Continuing Airworthiness Notice – 76-001

Gippsland GA8 Throttle Cable

05 July 2007

The photo below shows the reconfigured installation to achieve adequate clearance between the female rod end, the penny washer and the throttle lever.

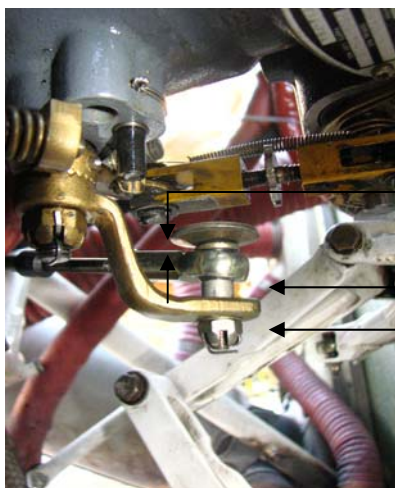
A thicker spacer fitted to allow sufficient clearance to avoid contact between the penny washer and the female rod end.

Longer spacer fitted.

Nut P/N MS17825-3

To minimise the potential of contact between the female rod end and the penny washer, replace the rod end spacer P/N GA8-710011-17 on the penny washer side of the female rod end with a thicker spacer of the same specification.

To reduce the angle between the throttle cable and the throttle lever replace the rod end spacer P/N GA8-710011-17 on the throttle lever side of the female rod end with a longer spacer of the same specification. The longer spacer increases the clearance between the female rod end and the throttle lever and reduces the angle of approach of the throttle cable.

To prevent loosening of the bolt and nut, replace bolt P/N AN3-11 with a drilled bolt P/N AN3-11 and replace nut P/N AN3-11 with a castellated nut P/N MS17825-3 and a split pin.
